Addendum #1

Date: November 19, 2021
Project: **Offsite Waterline Supply**
Lukachukai Community School Replacement
Location: Indian Route 12
Lukachukai, AZ 86507

RE: LCS & NHA Offsite Waterline, Lukachukai AZ – NTUA-HQ Review @ 'Pre-Final' Submittal

A horizontal number line with arrows at both ends. It has tick marks labeled 1 and 6.

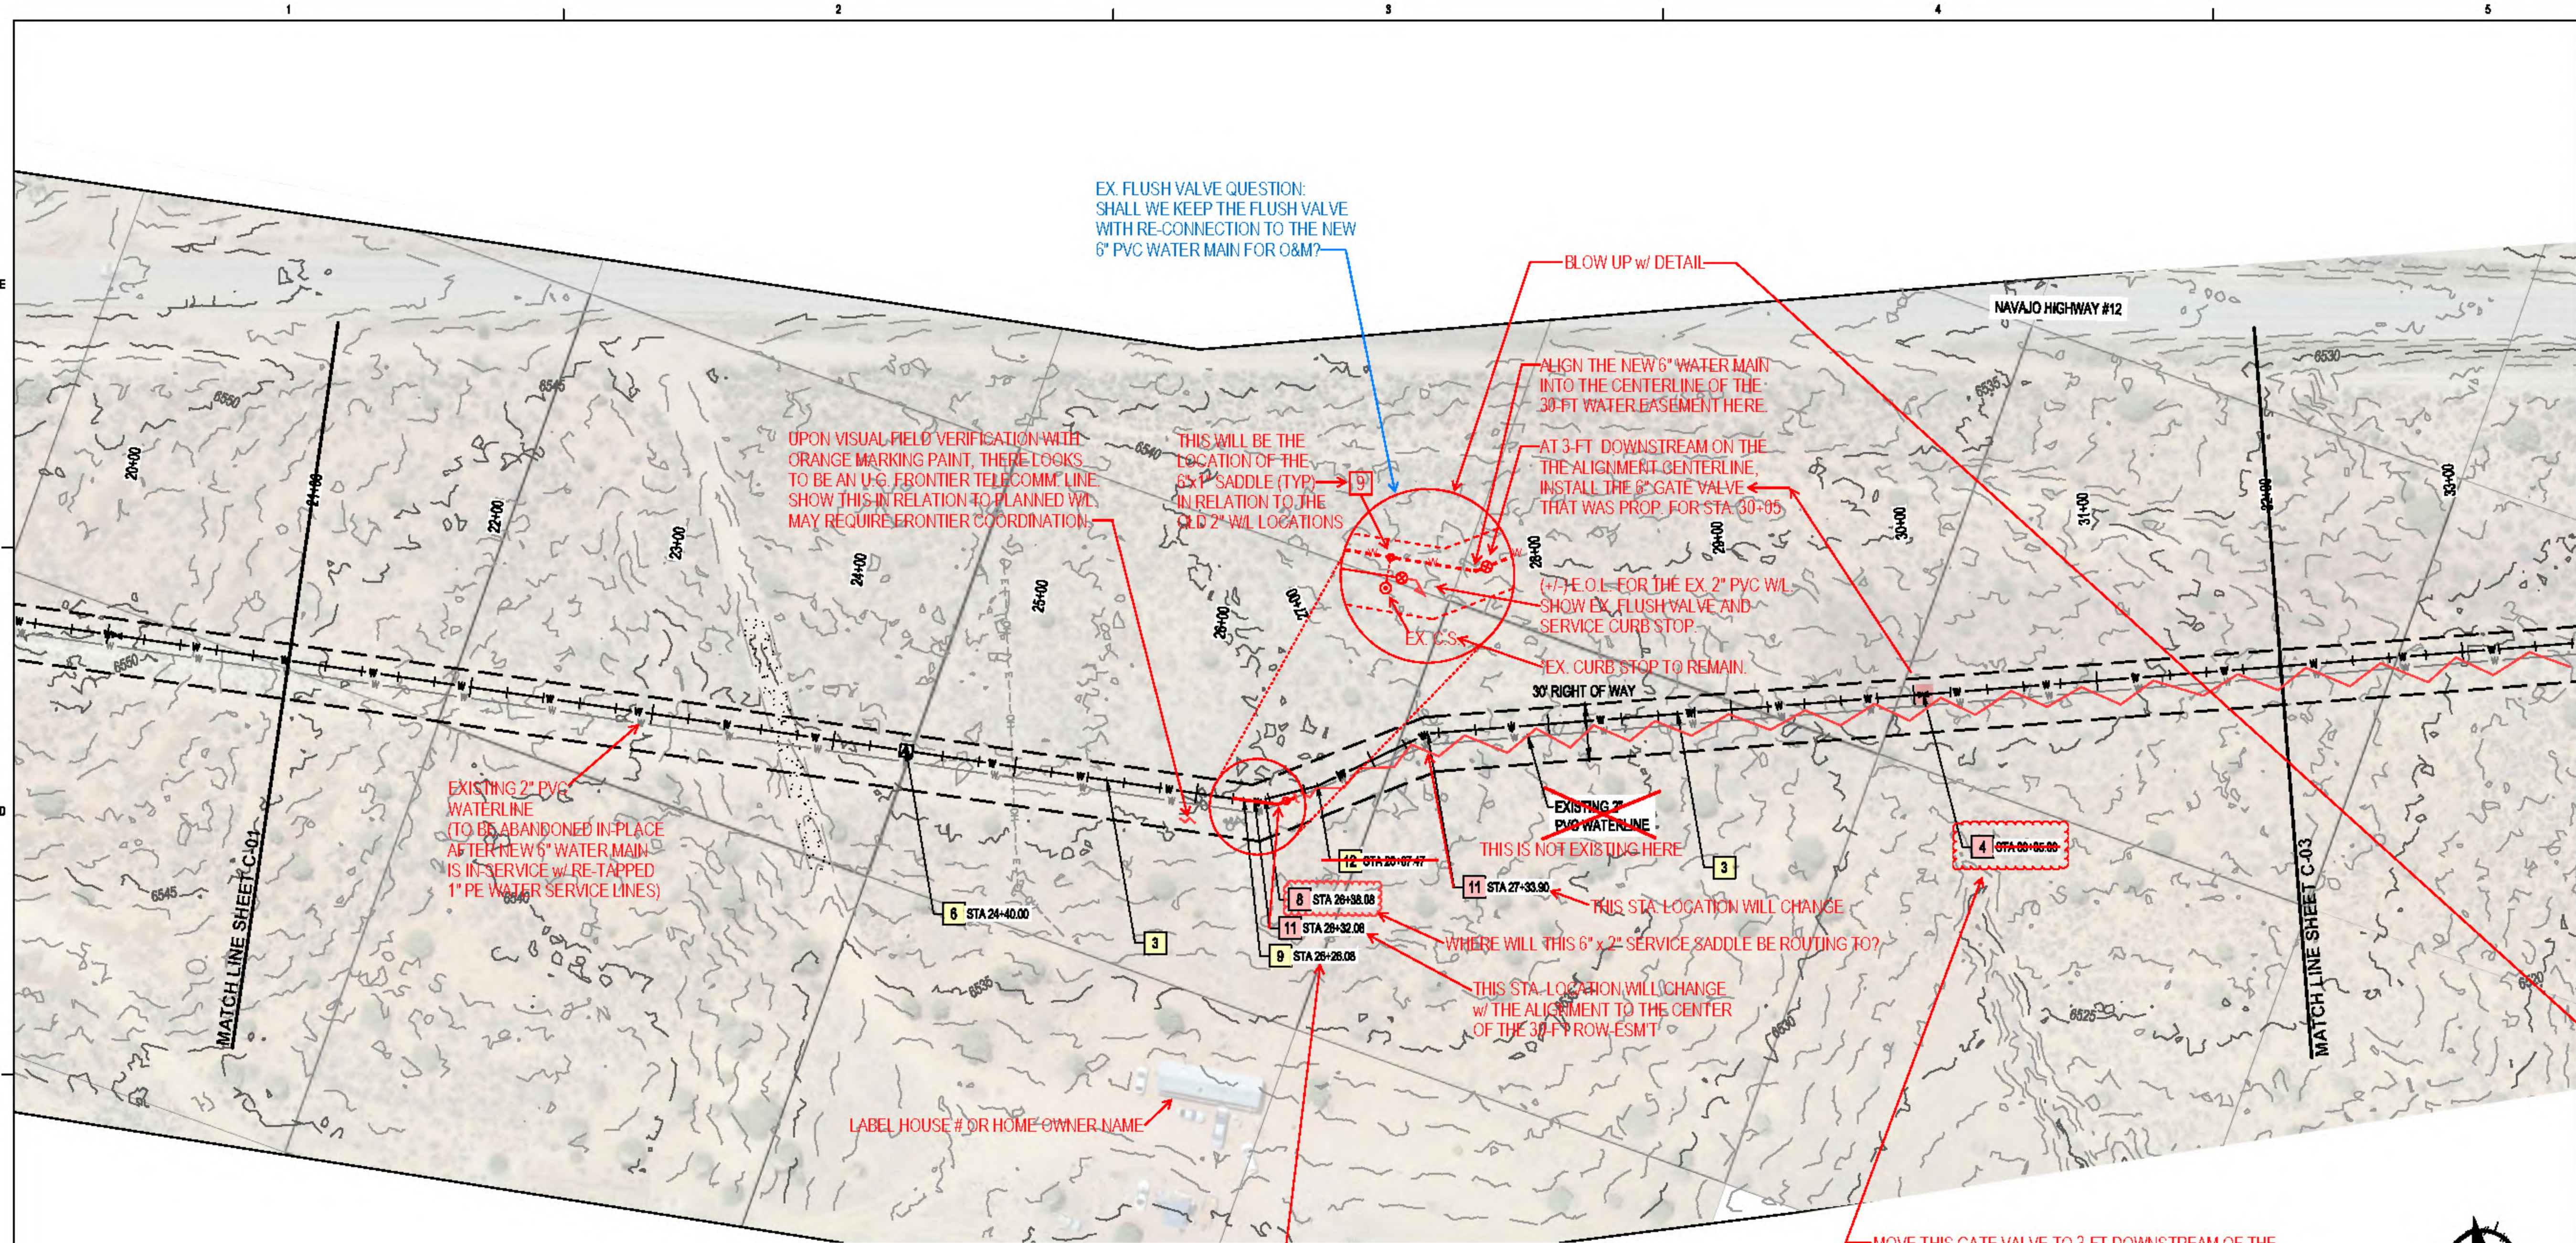
1. Ex. 6" PVC C900 W/L: Adjust/fix the ex. 6" transmission line alignment as shown on the plan sheet.
2. Show the required PRV data table on this Sheet C-01. The table shall include the PRV name/number, the size(s) which include the bypass, and the inlet and outlet settings.

3. Plan Keyed Notes #4 & #20: Justify the additional pressure relief valve & vault. (Surge Relief Valve Station per Dwg. 2353 on Sheet D-04) See Waterline Connection Detail review comments below.

4. Ex. 2" PVC W/L label: Also callout to be 'abandoned in-place' as shown on the plan sheet.
5. Sta. 20+05.00 (Proposed in-line 6" Gate Valve): Remove this proposed G.V. as it will not be required per IHS design standard for gate valve installations at 5,280-ft (1 mi.) segment increments or a change in design grade elevation of more than >50-ft vertically, or major alignment P.I./bend areas.

6. Keyed Notes: Make corrections to the key note descriptions as shown on the plan sheet.

1. Sta. 10+00 (Tapping Pt.): Tapping saddle not approved. Utilize 6" Tee, DI, MJ, w/ Thrust Block. Hot tap not approved, the ex. 6" high-pressured transmission line must be isolated and depressurized before tapping with the new 6" tee w/ transition piping & couplings as shown on the detail comments.

2. The ex. 6" high-pressured transmission line's current dynamic/static pressures must be checked and verified. Install the appropriate pressure rated PVC C900 pipe. Ductile iron application not approved.

3. Sta. 10+49.96 (Proposed 6" PRV w/in Manhole): Justify the additional pressure relief valve & vault. (Surge Relief Valve Station per Dwg. 2353 on Sheet D-04) These facilities are not required per the planned PRV @ Sta. 10+62.13 which should suffice the high-pressure incoming flow to the new 6" PVC C900 waterline. This is not an NTUA standard. The operating District Office will not operate & maintain (O&M) this facility.

4. Edit/add the additional minor text items/labels on the detail, as shown.

1. Proposed 11.25° Bends (Sta's 11+36, 11+56, 11+60, 11+78): Justify why these proposed bends are being installed at these Sta's. These bends are not shown on the plan view. If the bends are per vertical realignments for what looks to be a minor local drainage ditch, also callout on the plan view.

2. INSTALL 6" DUCTILE IRON WATERLINE. ← A DUCTILE IRON (DI) APPLICATION NOT APPROVED HERE

3. INSTALL 6" DR18 C900 PVC WATERLINE. ← LABEL/SHOW PRESSURE/CLASS (TYP)

JUSTIFY THE ADDITIONAL PRV;
SEE DETAIL THIS SHEET FOR
ADDITIONAL COMMENT

TAPPING SADDLE NOT APPROVED.
USE 6" TEE, DI, MJ, w/ THRUST BLOCK.

THESE FACILITIES ARE NOT REQUIRED. JUSTIFY THE PROPOSAL FOR THESE ITEMS.

REMOVE THIS IN-LINE GATE VALVE:
NOT REQUIRED AT THIS LOCATION.
SEE REVIEW COMMENTS LETTER.

SHEET NO. **C-02** OF

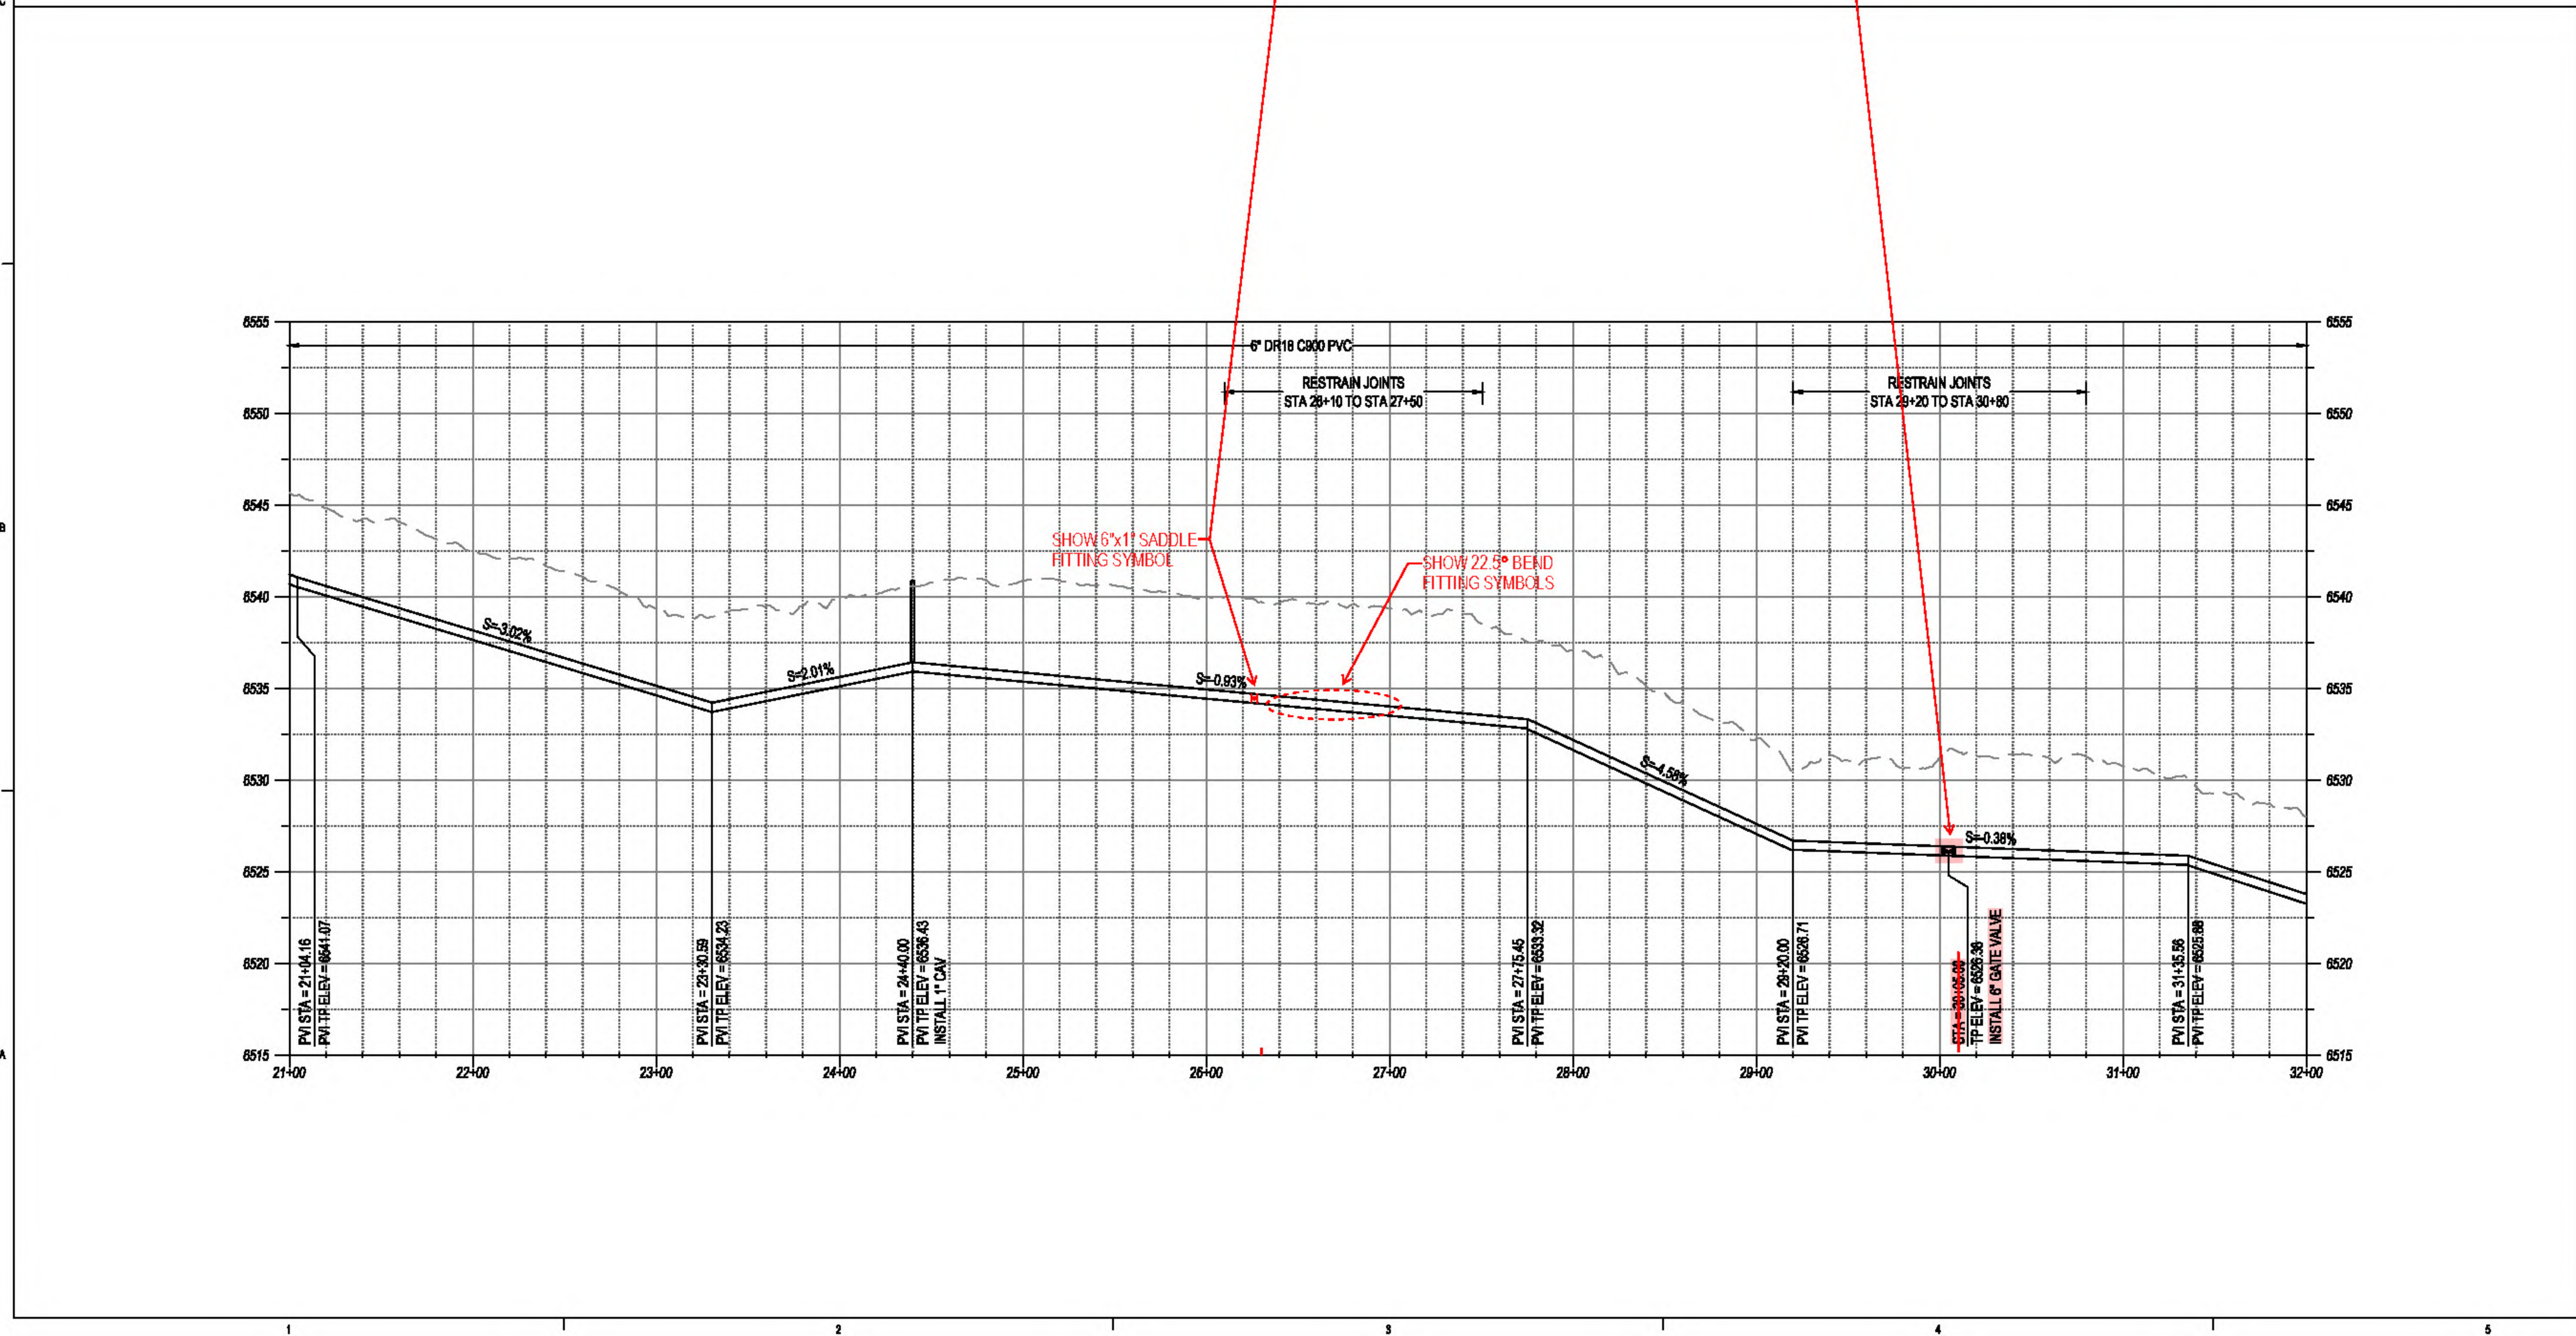
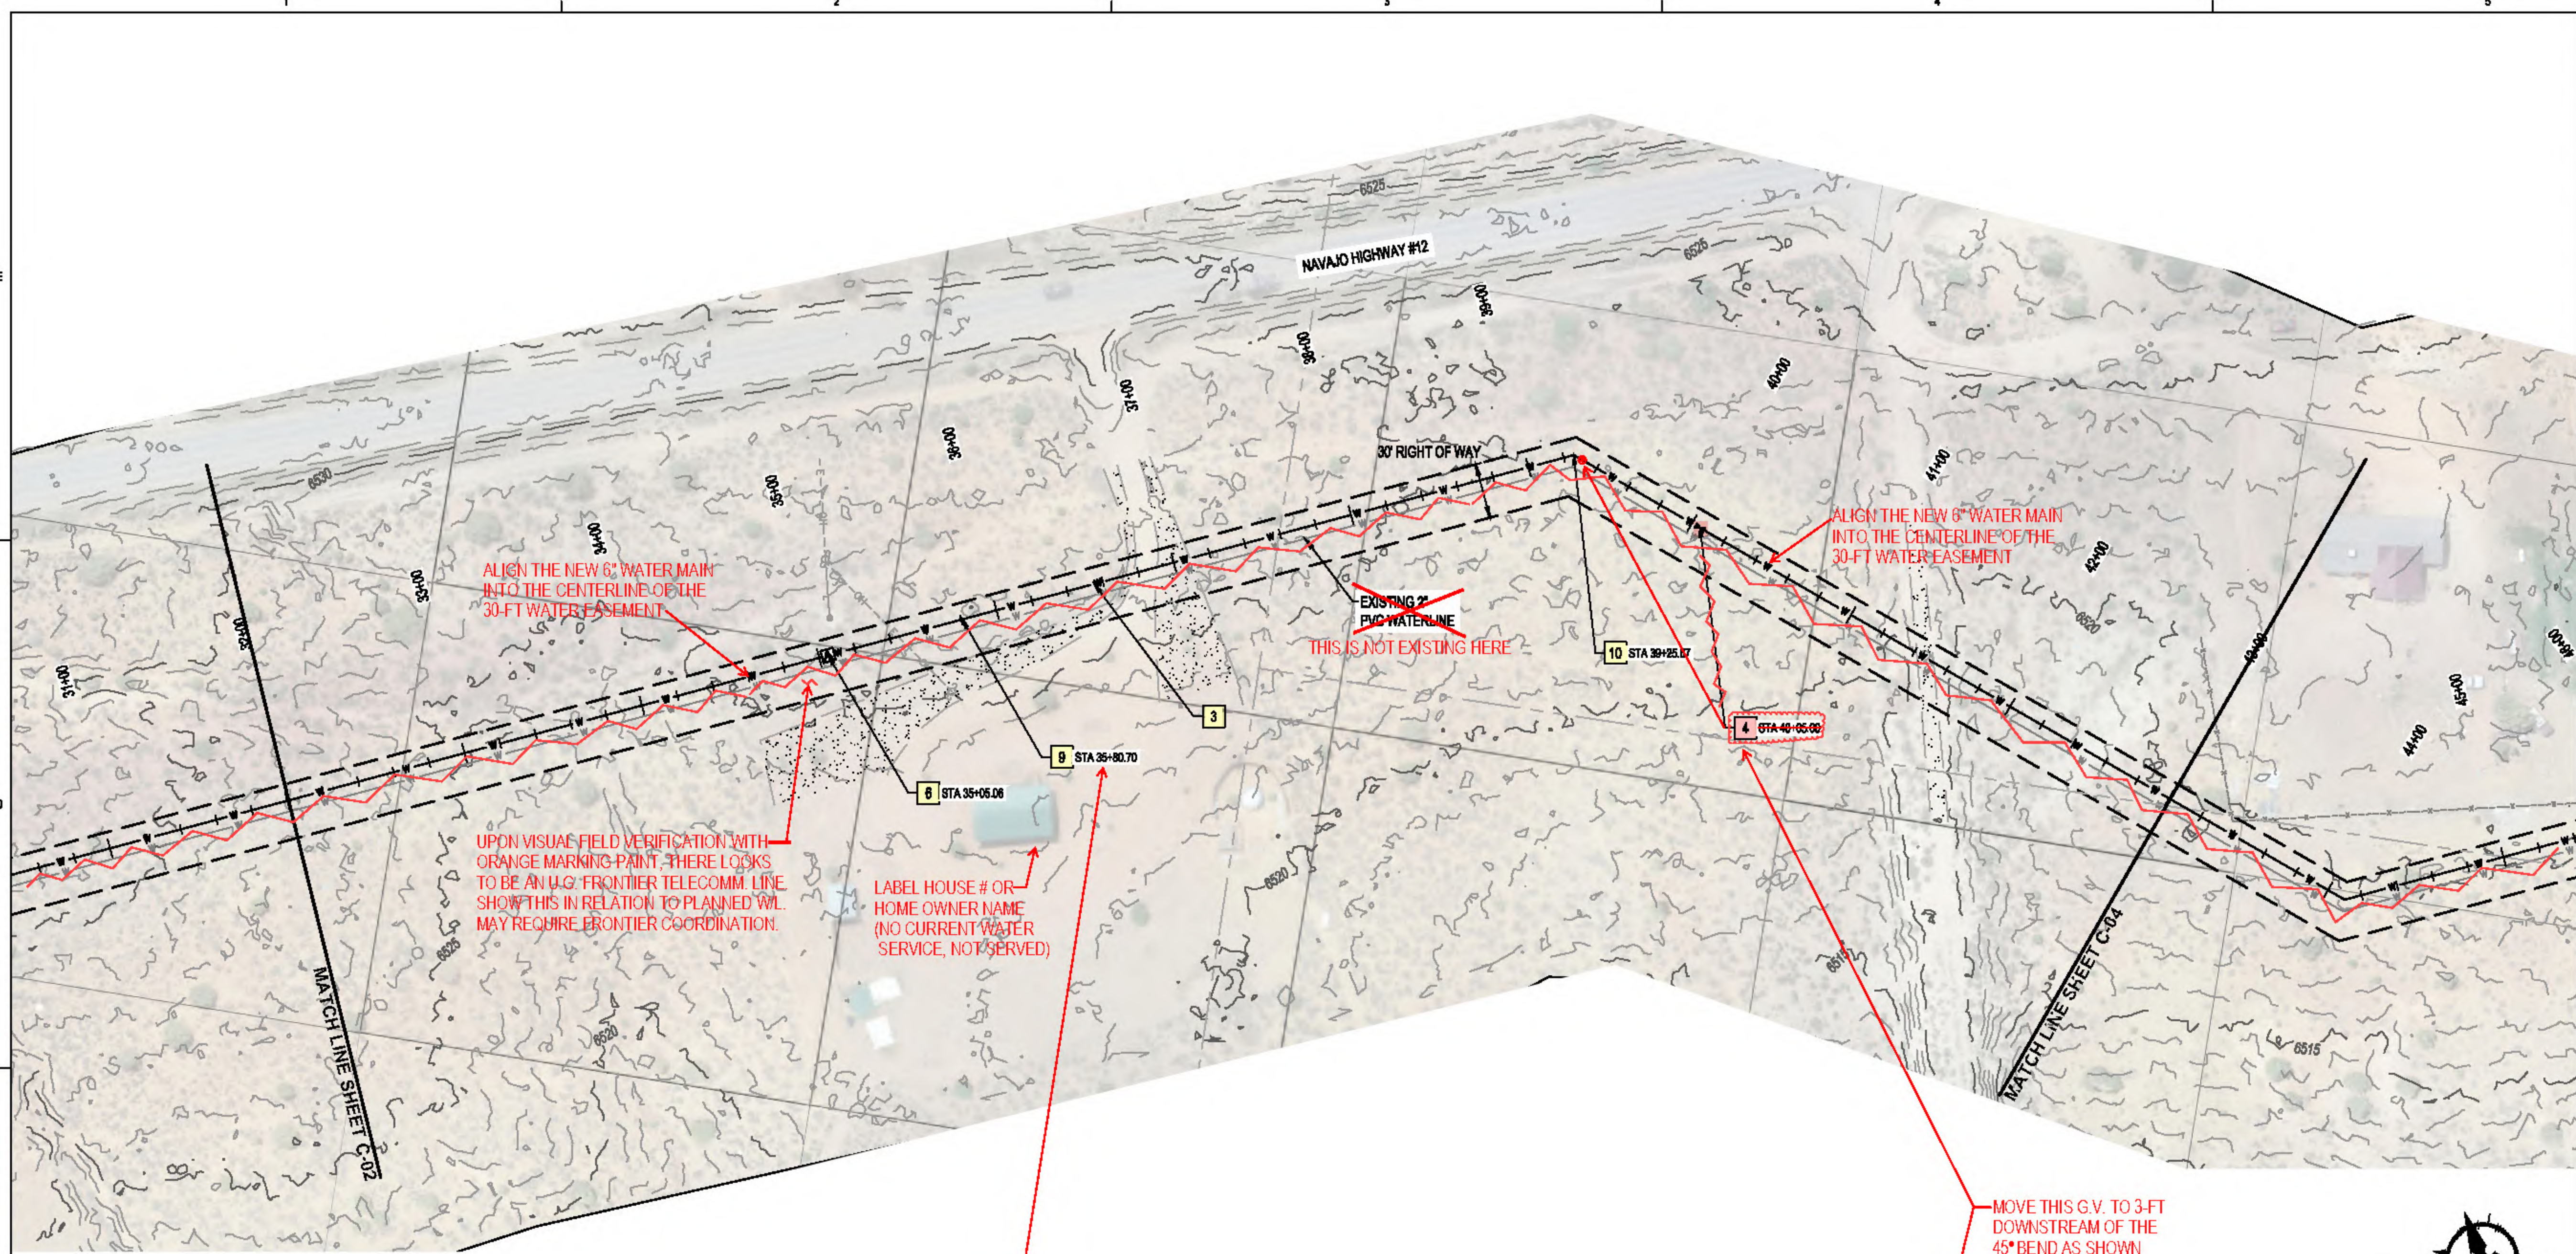
1. Ex. 2" PVC W/L: Callout the ex. 2" waterline **only** from Sta. 21+00 to Sta. 26+30(+/-). This approximate Sta. area is where the ex. 2" waterline ends. Adjust/fix the ex. 2" waterline alignment to end here, as shown on the plan sheet. Also callout to be 'abandoned in-place' as shown. Delete/erase the shown ex. 2" waterline alignment that is shown from Sta. 26+30(+/-) to Sta. 32+00, which is the matchline for this sheet. This does not exist in the field.

2. EOL for ex. 2" W/L: Blow up the EOL area with a detail bubble as shown on the plan sheet. Show/add the detail bubble review comments as shown per the ex. water facilities near the EOL.

3. Ex. Curb Stop at ex. Homesite: The ex. curb stop to remain, protect in-place. The new 6"x1" saddle tap on the new 6" water main will align directly in-line w/ the ex. curb stop location. Future water service re-connection will utilize the ex. curb stop. Also, label the House No. # and/or Homeowner name (typ).

4. New 6" PVC C900 W/L alignment: At or near Sta. 26+40(+/-), align the new 6" water main into the centerline of the new 30-ft water easement/ROW here. See plan sheet/detail bubble for reference.

5. Planned/future bends on the new 6" water main: The Sta. locations of the bends will change per the shift of the 6" water main into the center of the 30-ft water easement. Adjust the Sta. locations.

6. Sta. 26+38.08 (6"x2" service saddle): Where/who will this 2" water service alignment be routing to?
7. Sta. 30+05.00 (Proposed 6" in-line Gate Valve): Move/revise this gate valve to 3-ft downstream of the revised bend area once the 6" water main alignment shifts to the centerline of the 30-ft water easement, as shown in the requested future detail bubble of the EOL area of the ex. 2" waterline.

8. Ex. Frontier telecommunications/fiber line: Upon visual field verification, there looks to be an underground (UG) telecommunications line field marked w/ orange marking paint and ex. pedestals. Show this ex. Frontier line in relation to the planned 6" water main on the plan. May require coordination with the local Frontier utility office. The line looks to be following the NHA survey stakes going northbound to the next homesite residence. Possible conflict and/or Frontier relocation.

9. Keyed Notes: Make corrections to the keynote descriptions as shown on the plan sheet.

1. Planned fitting symbols: Show/label the saddle and bend symbols in the profile, as shown.
